<p>James C. Porter, Director County Government Center 555 County Center, 5th Floor - Redwood City, CA 94063 www.smcgov.org</p>	ADDENDUM NO. 2
	Project No. P30J1 Grant Yard Radio Shop Project Redwood City, CA
	Issue Date: January 11, 2021

This Addendum No. 2, dated January 11, 2021, includes the following:

C505
5HH57 < A9BH'8

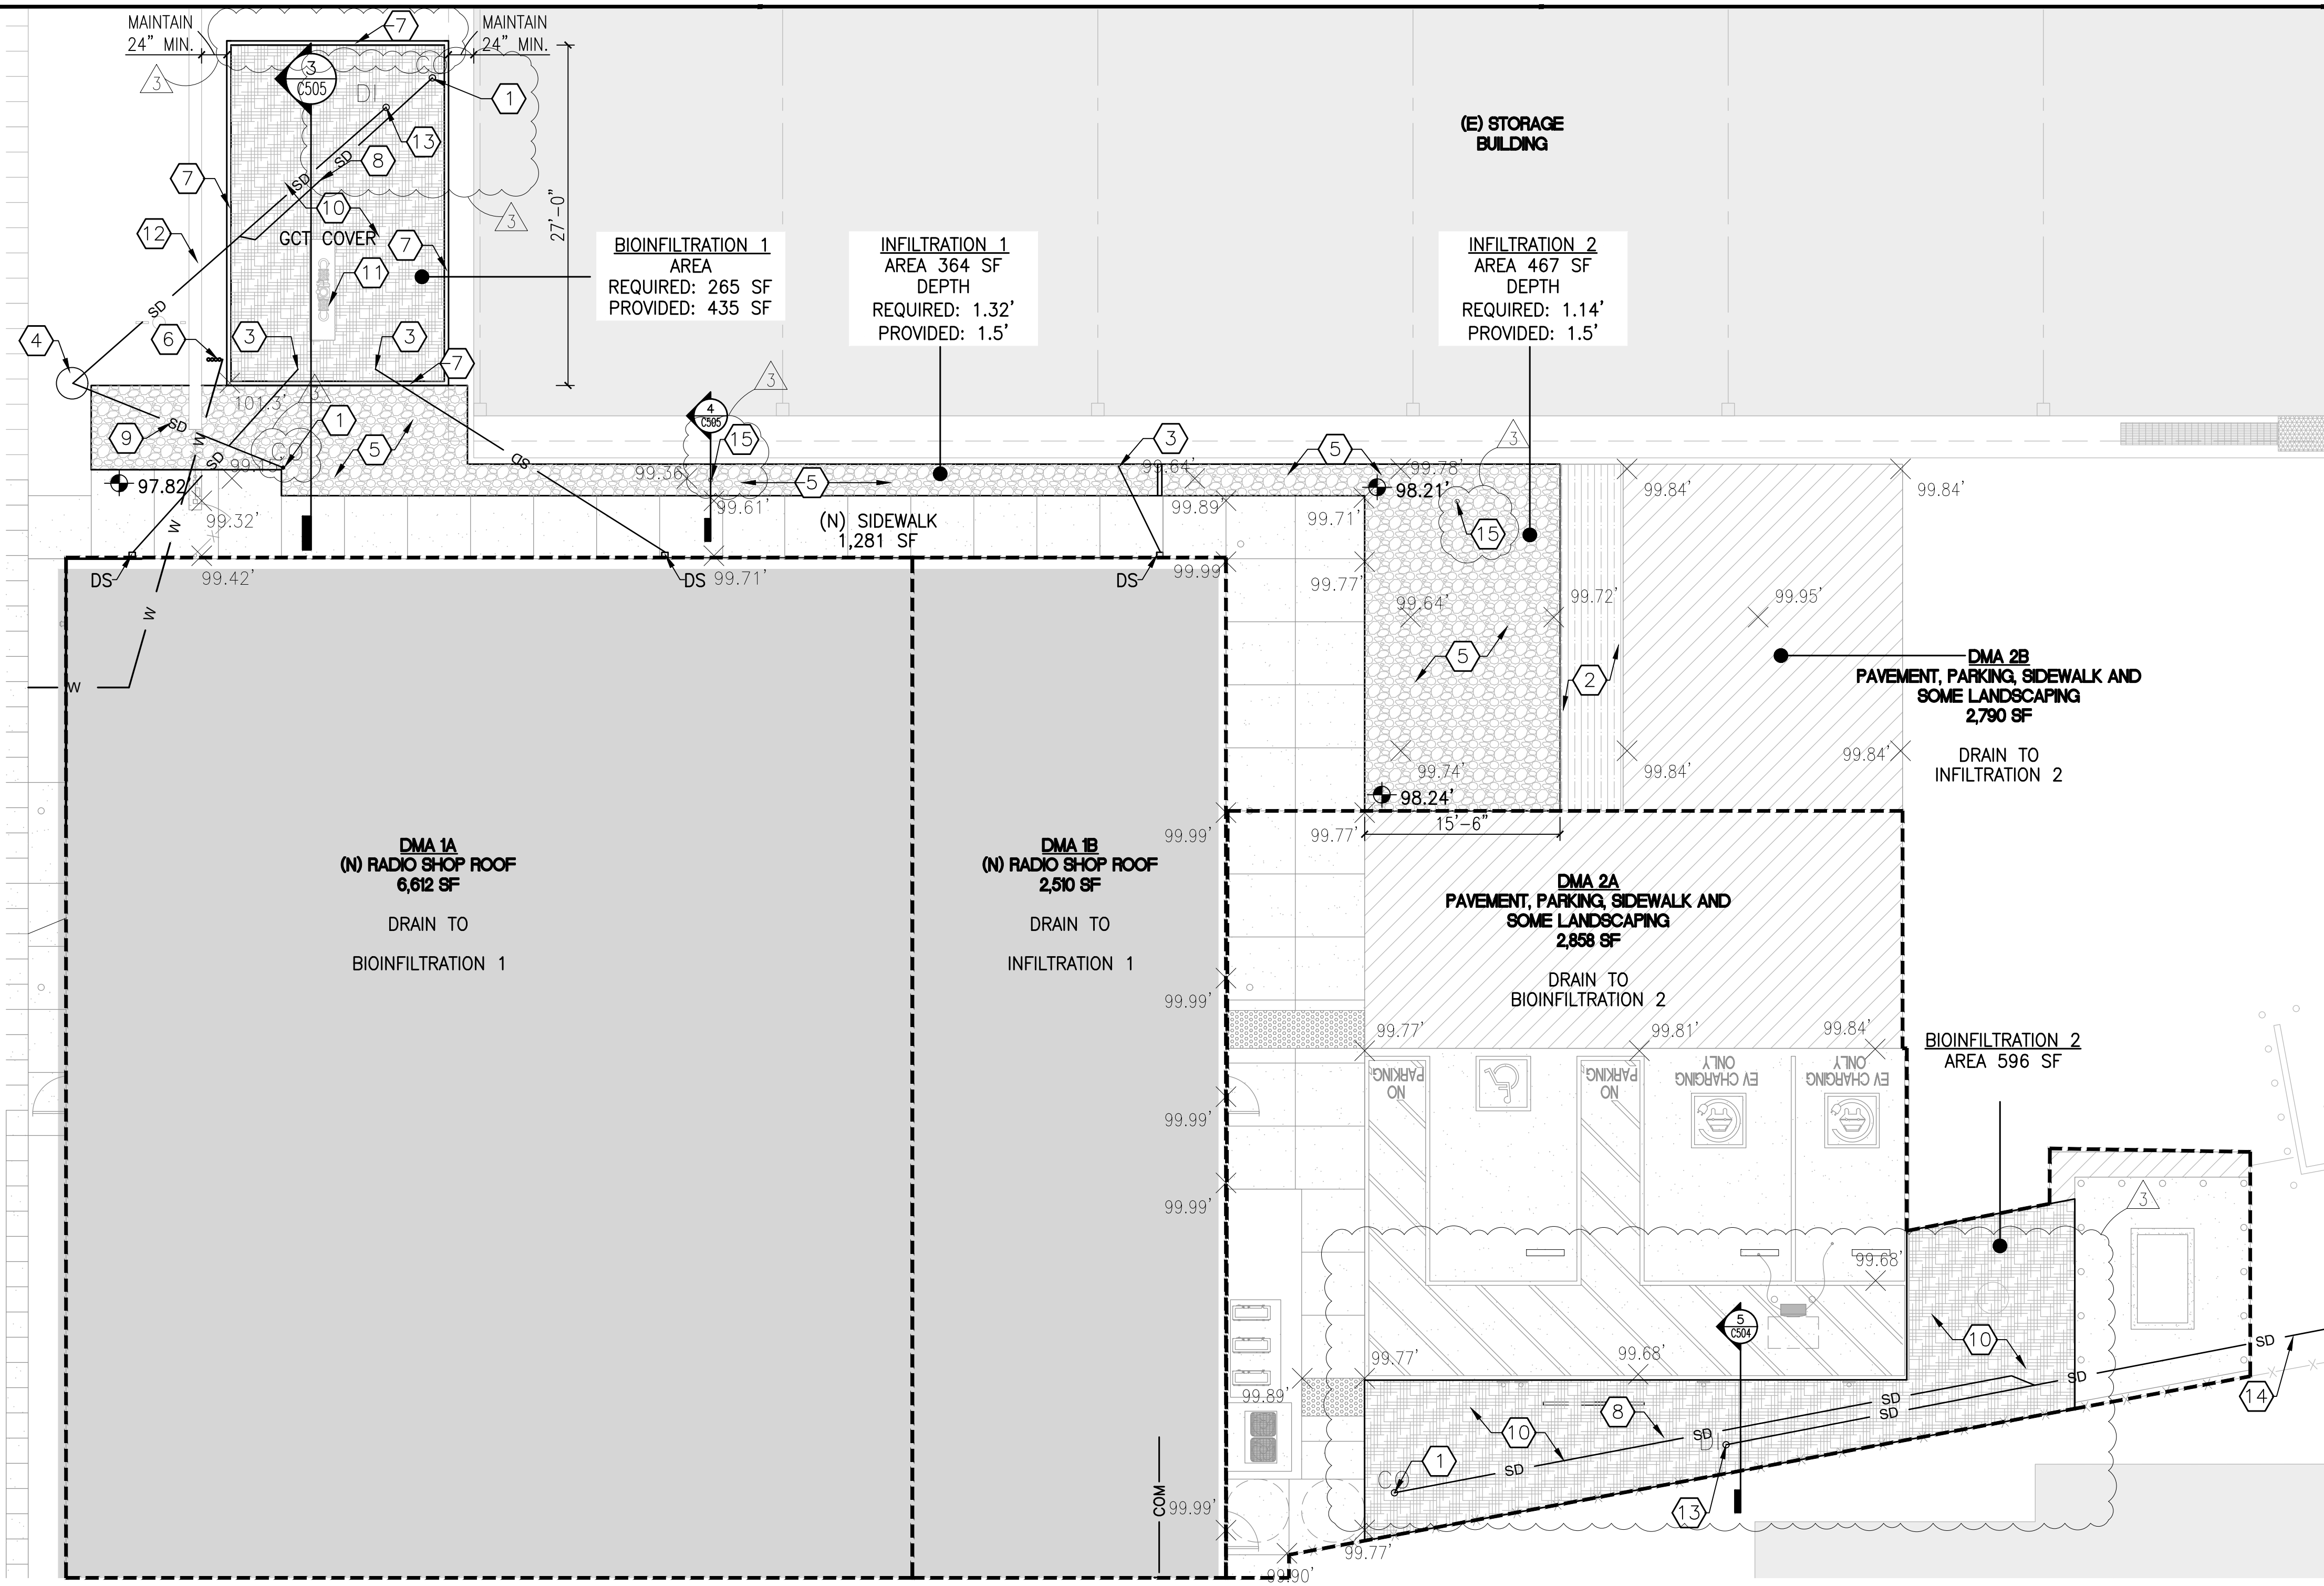
- I. Modifications or Clarifications to the Contract Documents & Contracting Requirements (Drawings, Specifications, Project Manual)**
 - A. Drawing L113 -Stormwater calculations revised, no impact on site design. See Attachment 1.
 - B. Drawing C505, Note 1 - Cleanouts at underdrain PVC piping shown in site plan. view. North biofiltration basin, north infiltration trench and east biofiltration area. See Attachment2.
 - C. Drawing C505, Note 1, 8, and 13 - Cleanout, perforated underdrain, overflow drain inlet, solid PCV drain pipe to manhole shown in plan for clarity at north biofiltration basin. See Attachment2.
 - D. Drawing C505, Notes 1, 8, 13 and 14 - Added for clarity and piping extended at east biofiltration area (Note 11). See Attachment2.
 - E. Drawing C505, Note 14 -Underdrain solid 4" PVC drainage pipe connection distance of approx. 118'-0". See Attachment2.

PLAN NORTH
1 BIOINFILTRATION BASIN WITH UNDERDRAIN
 1/8" = 1'-0"

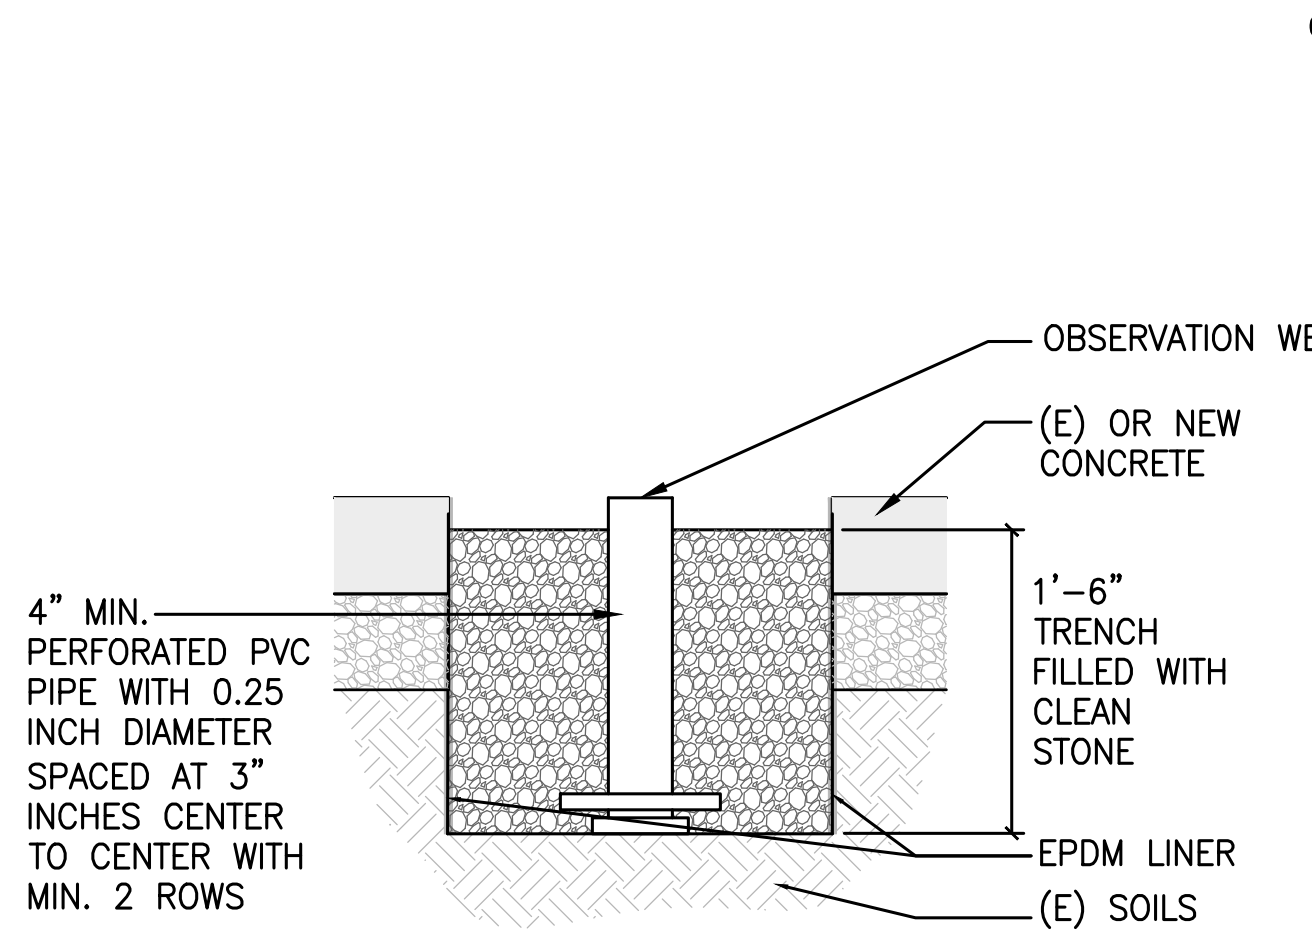
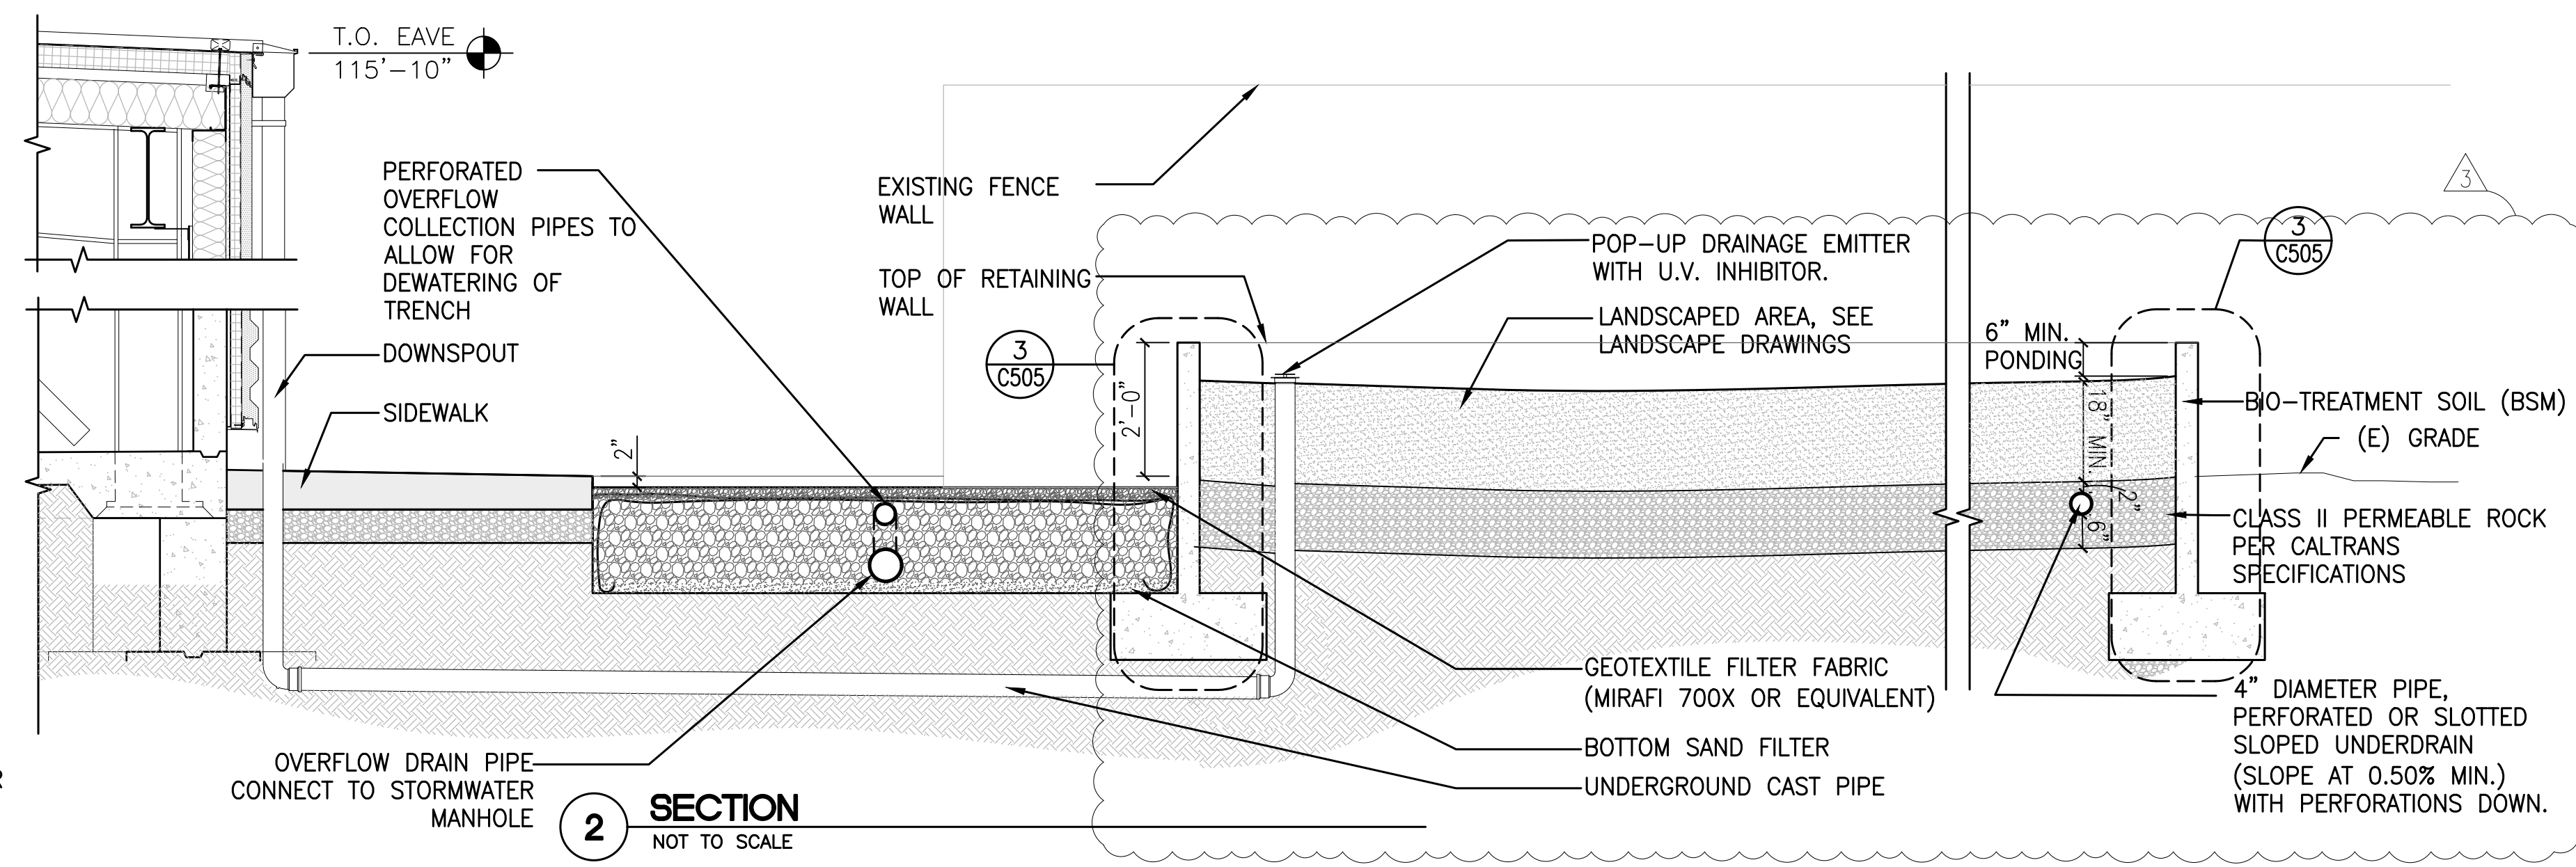
- F. Drawing C505, Note 15 - Location of PVC observation wells shown to infiltration trench. See 4/C505. See Attachment2.
- G. Drawing C505, Detail 1, 2 and 3 -Concrete retaining end wall added to north biofiltration to create basin. See Attachment2.
- H. Drawing C505, Detail 4 - Waterproof EPDM liner extended to bottom and sides of infiltration trench. See Attachment2.
